Docket No. 52-021
MHI Ref: UAP-HF-08179

Subject: MHI's Responses to US-APWR DCD RAI No. 41 through 44

US-APWR Design Certification

Figure 02.03.04-1 Site Plan with Release and Intake Locations

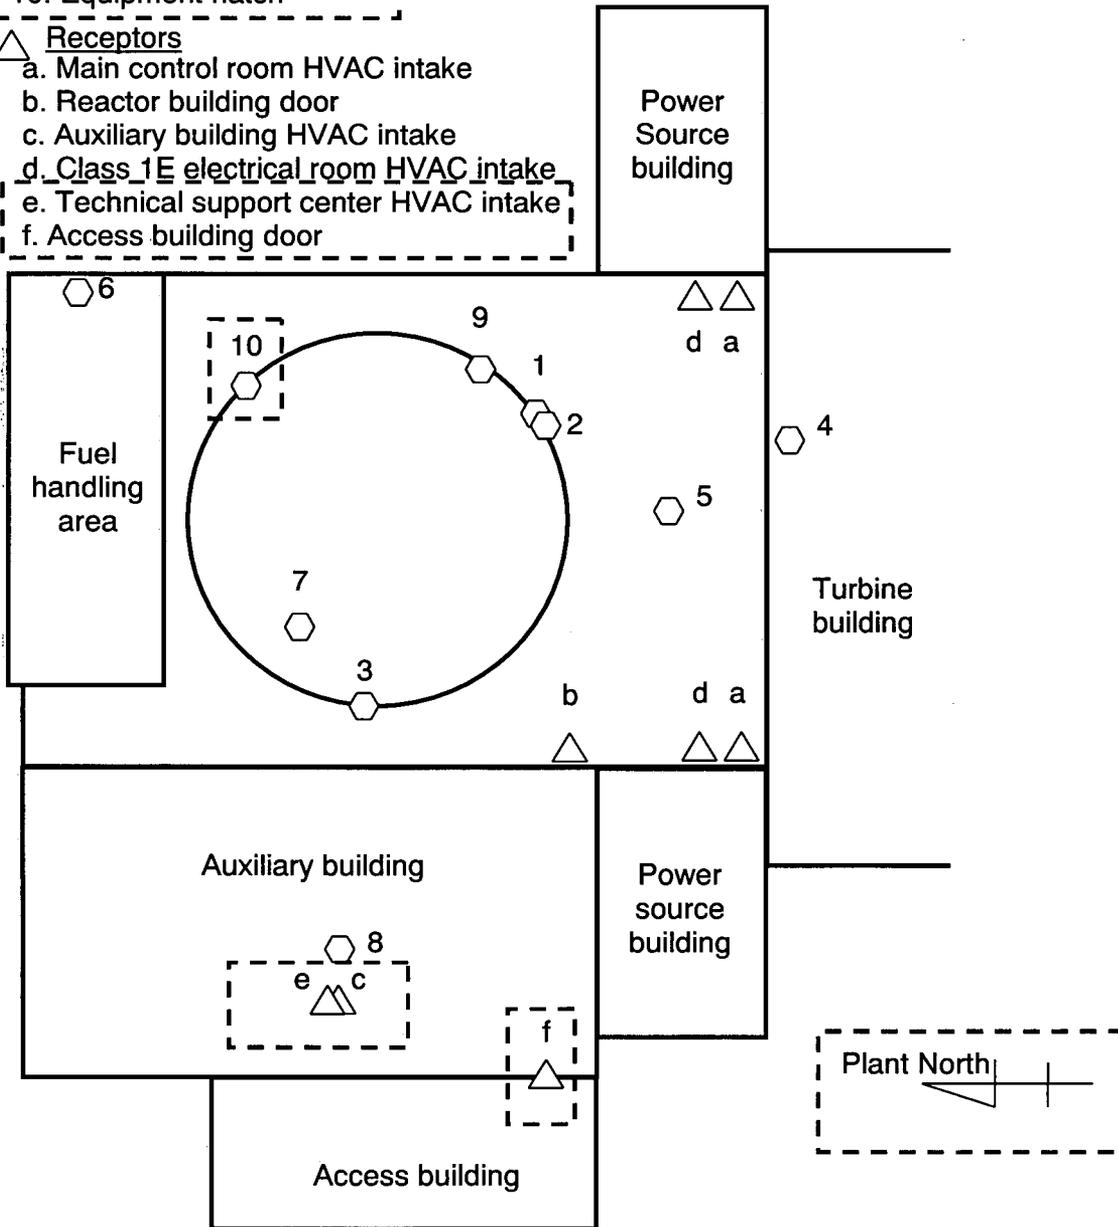
Revise DCD Tier 2 Figure 15A-1 to (1) indicate plant north and (2) add the technical support center (TSC) intake and inleakage locations.

The applicant stated in DCD Tier 2 Section 15.6.5.5.1.3 that the dose calculation model used to evaluate main control room (MCR) habitability for the loss-of-coolant accident (including source term, transport, and release assumptions) were also used to evaluate the TSC habitability for the same event. The applicant also stated that the distances from release points to receptors are almost the same between the TSC and MCR; therefore, the radiological consequences in the TSC are represented by those in the MCR. DCD Tier 2 Figure 15A-1 is a site plan showing release locations and MCR receptors. The TSC intake and inleakage locations should be added to Figure 15A-1 to confirm the applicant's statement that the distances from release points to receptors are almost the same between the TSC and MCR.

Figure 02.03.04-1 is a site plan showing release locations and, MCR and TSC receptors for the US-APWR. MHI will revise DCD Tier 2 Figure 15A-1 to (1) indicate plant north and (2) add the TSC intake and inleakage locations. Modified places from DCD Tier 2 Figure 15A-1 are shown by dotted line frames in Figure 02.03.04-1.

- Revise DCD Tier 2 Figure 15A-1 to indicate plant north and add the technical support center (TSC) intake and inleakage locations as indicated in Figure 02.03.04-1.
